## Accessibility Construction Site Inspection

2nd Visit

Emerald Valley Apartments  
711 Rural St  
Evergreen, AL 36401

Findings & Issues March 13, 2024  
Site Visit

## #45 - Thermostat above 48 inches

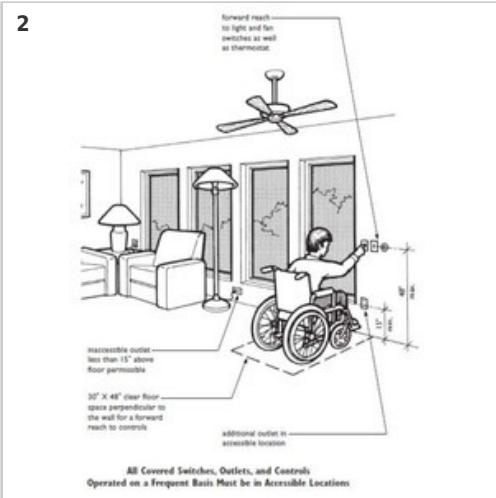
Scott Reynolds	Photo 1	11 Dec 07:20 AM
Alva George	Fair Housing Act Design Manual - Requirement 5 -Light Switches, Electrical Outlets, Thermostats, and Other Environmental Controls in Accessible Locations	13 Dec 07:37 AM
Alva George	Photo 2	13 Dec 07:38 AM
Alva George	ANSI A117.1[2003]1004.9 Operable Parts. Lighting controls electrical switches and receptacle outlets, environmental controls, and user controls for security or intercom systems shall comply with Sections 309.2 and 309.3.	13 Dec 07:42 AM
Alva George	Locate controls at 48 inches or below.	13 Dec 07:42 AM

## #16 - Toilet not 18 inches-Provide clear floor space at water closet.

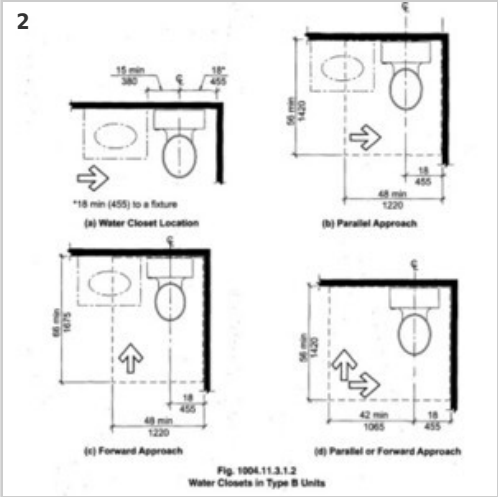
Scott Reynolds	Photo 1	11 Dec 06:33 AM
Alva George	Photo 2	12 Dec 08:40 AM
Alva George	Fair Housing Act Design Manual - Requirement 7 Usable Kitchens and Bathrooms Part A:Usable Kitchens Part B: Usable Bathrooms	12 Dec 08:43 AM

#46 - Thermostat above 48 inches

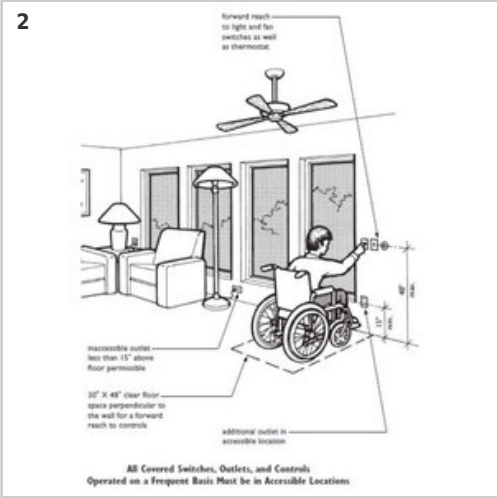
Scott Reynolds	Photo 1	11 Dec 07:21 AM
Alva George	Fair Housing Act Design Manual - Requirement 5 -Light Switches, Electrical Outlets, Thermostats, and Other Environmental Controls in Accessible Locations	13 Dec 08:14 AM
Alva George	Photo 2	13 Dec 08:14 AM
Alva George	ANSI A117.1[2003]1004.9 Operable Parts. Lighting controls electrical switches and receptacle outlets, environmental controls, and user controls for security or intercom systems shall comply with Sections 309.2 and 309.3. Locate controls at 48 inches or below.	13 Dec 08:14 AM

● **#47 - Thermostat above 48 inches**  
Priority 2 | Scott Reynolds | 2023-12/11 1st Visit  
Plan: A2.1 - FIRST FLOOR BUILDING PLAN | Location: 103  
Created 12-11-2023

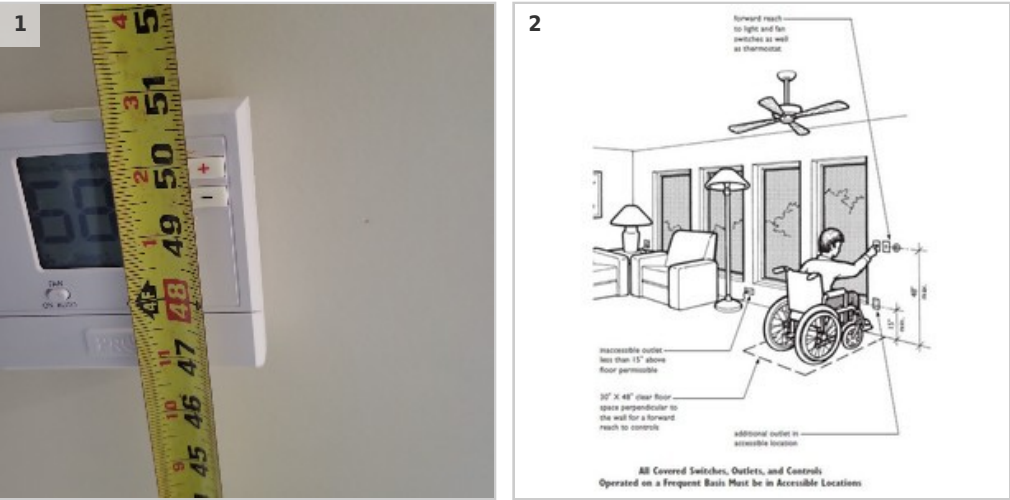
Task messages (time in PDT)		
Scott Reynolds	Photo 1	11 Dec 07:22 AM
Alva George	Fair Housing Act Design Manual - Requirement 5 -Light Switches, Electrical Outlets, Thermostats, and Other Environmental Controls in Accessible Locations	13 Dec 08:16 AM
Alva George	Photo 2	13 Dec 08:16 AM
Alva George	ANSI A117.1[2003]1004.9 Operable Parts. Lighting controls electrical switches and receptacle outlets, environmental controls, and user controls for security or intercom systems shall comply with Sections 309.2 and 309.3. Locate controls at 48 inches or below.	13 Dec 08:19 AM

● **#21 - Toilet not 18 inches-Provide clear floor space at water closet.**  
Priority 2 | Scott Reynolds | 2023-12/11 1st Visit  
Plan: A2.1 - FIRST FLOOR BUILDING PLAN | Location: 104  
Created 12-11-2023

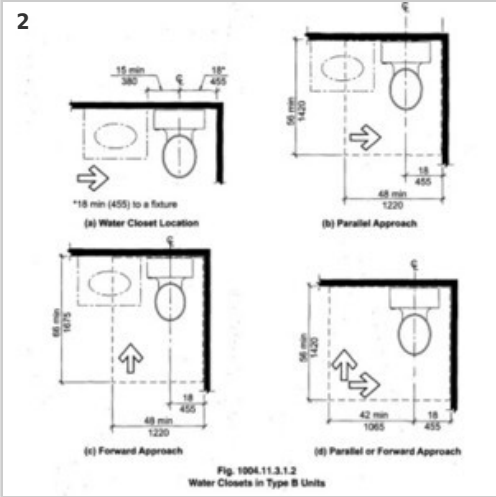
Task messages (time in PDT)		
Scott Reynolds	Photo 1	11 Dec 06:39 AM
Alva George	Photo 2	12 Dec 10:17 AM
Alva George	Fair Housing Act Design Manual - Requirement 7 Usable Kitchens and Bathrooms Part A:Usable Kitchens Part B: Usable Bathrooms	12 Dec 10:17 AM

#28 - Toilet not 18 inches

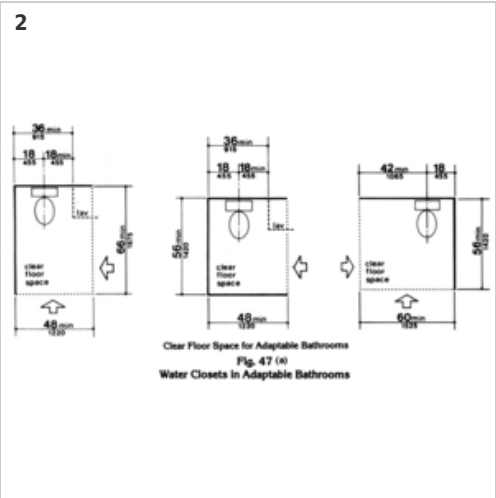
Scott Reynolds	Photo 1	11 Dec 06:54 AM
Alva George	Photo 2	12 Dec 01:31 PM
Alva George	UFAS 4.34.5.2 WATER CLOSETS.	12 Dec 01:31 PM

(1) Clear floor space at the water closet shall be as shown in Fig. 47(a). The water closet may be located with the clear area at either the right or left side of the toilet.

**#37 - Shower not 30 by 60 inches**

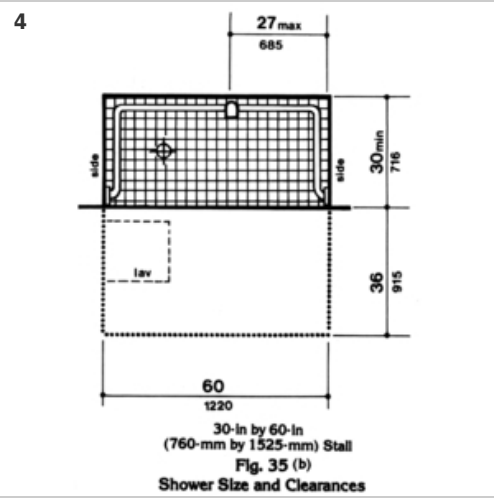
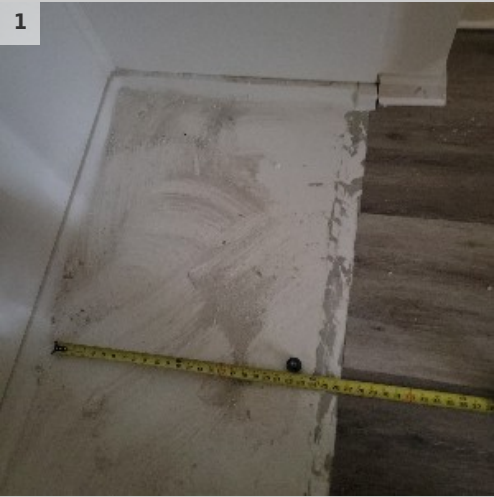
Task messages (time in PDT)		
Scott Reynolds	Photo 1	11 Dec 07:06 AM
Scott Reynolds	Photo 2	11 Dec 07:06 AM
Scott Reynolds	Photo 3	11 Dec 07:07 AM
Alva George	4.34.5.5 SHOWERS. If a shower is provided, it shall have the following features:  (1) Size and clearances. Shower stall size and clear floor space shall comply with either Fig. 35(a) or (b). The shower stall in Fig. 35(a) shall be 36 in by 36 in (915 mm by 915 mm). The shower stall in Fig. 35(b) will fit into the same space as a standard 60 in (1525 mm) long bathtub.	13 Dec 06:51 AM
Alva George	Photo 4	13 Dec 06:51 AM

● **#189 - Lavatory center not at 24 inches**  
Priority 2 | Scott Reynolds | 2024-3/13 Site Visit  
Plan: A2.1 - FIRST FLOOR BUILDING PLAN | Location: 101  
Created 03-13-2024

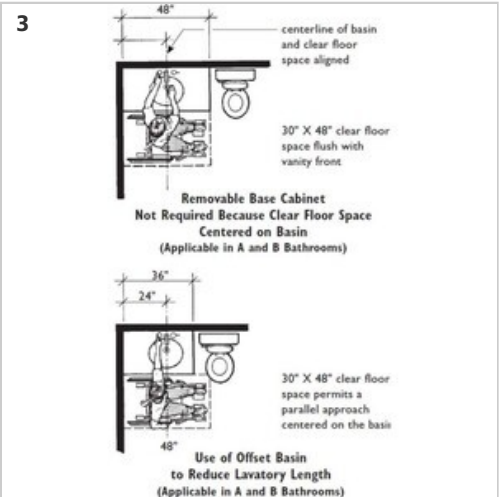
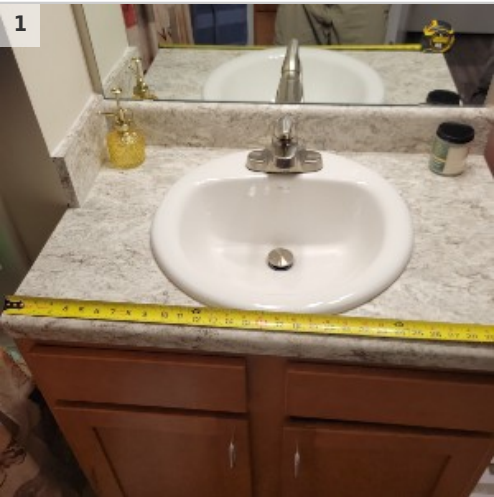
Scott Reynolds	Photo 1	13 Mar 07:02 AM
Scott Reynolds	Photo 2	13 Mar 07:02 AM
Alva George	Photo 3	14 Mar 10:03 AM
Alva George	Fair Housing Act Design Manual-Requirement 7 - Usable Kitchens and Bathrooms	14 Mar 10:49 AM
Alva George	Relocate lavatory	14 Mar 10:50 AM

**#200 - Shower control not off set.**  
Priority 2 | Scott Reynolds | 2024-3/13 Site Visit  
Plan: A2.1 - FIRST FLOOR BUILDING PLAN | Location: accessible 111  
Created 03-13-2024

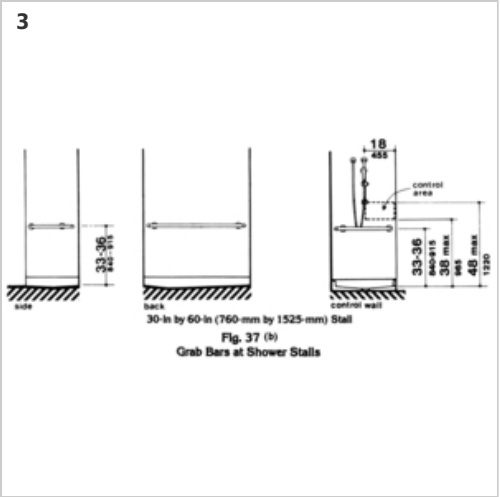
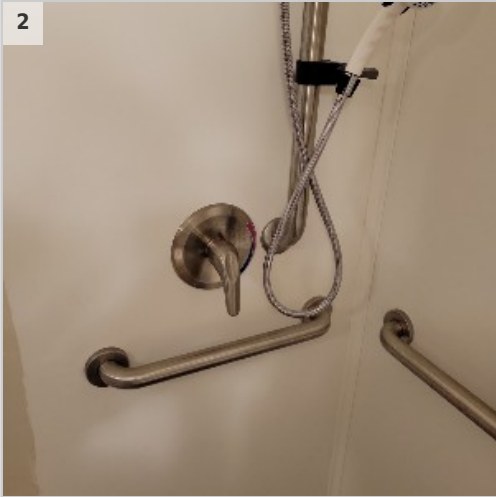
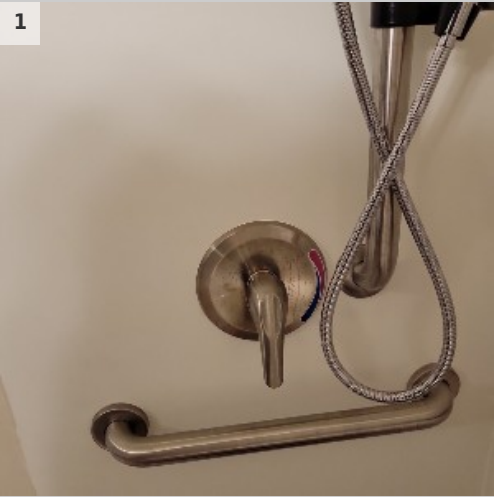
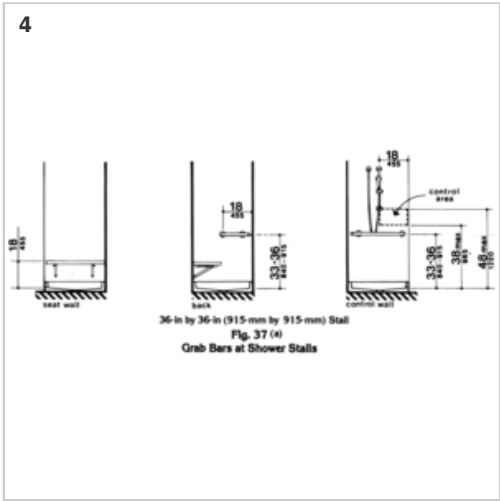
Scott Reynolds	Photo 1	13 Mar 07:58 AM
Scott Reynolds	Photo 2	13 Mar 07:59 AM
Alva George	UFAS 4.34.5.5 SHOWERS. If a shower is provided, it shall have the following features:(4) Controls. Faucets and other controls shall be located as shown in Fig. 37 and shall comply with 4.27.4. In the shower stall in Fig. 35(a), all controls, faucets, and the shower unit shall be mounted on the side wall opposite the seat.	14 Mar 12:49 PM
Alva George	Photo 3	14 Mar 12:50 PM
Alva George	Photo 4	14 Mar 12:51 PM

● **#205 - Needs 5th accessible parking space**  
Priority 2 | Scott Reynolds | 2024-3/13 Site Visit  
Plan: 01. - Accessibility Plan | Location: second row parking lot  
Created 03-13-2024

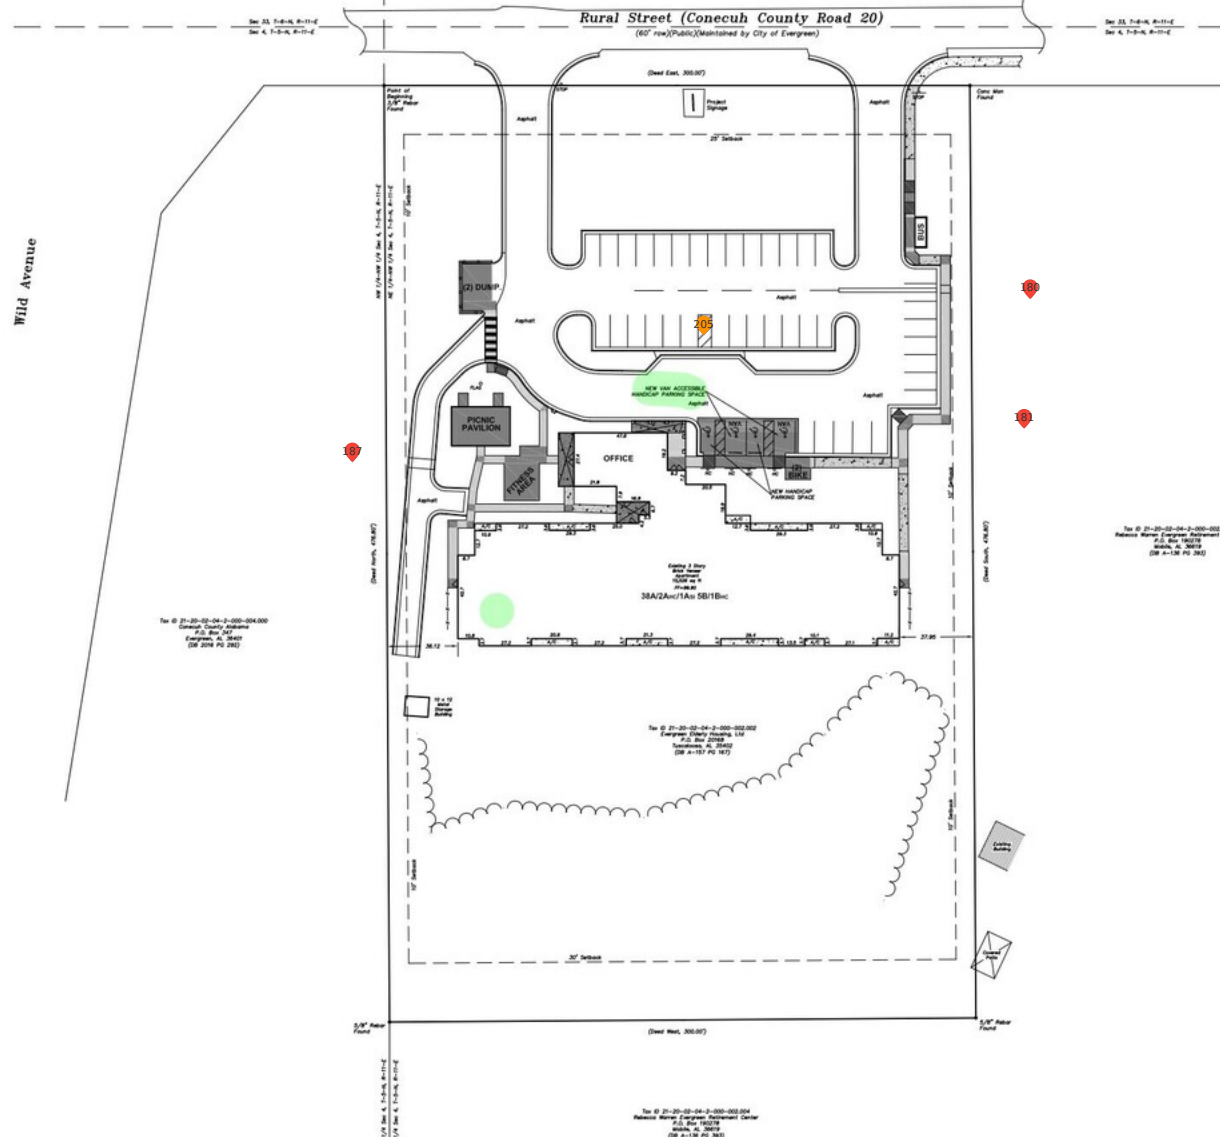
Scott Reynolds	Photo 1	13 Mar 09:28 AM
Alva George	Note the accessible route will take a parking space and the access aisle. Plans show [2] Van Accessible Parking Spaces and two Standard Accessible Parking Spaces.	14 Mar 01:13 PM
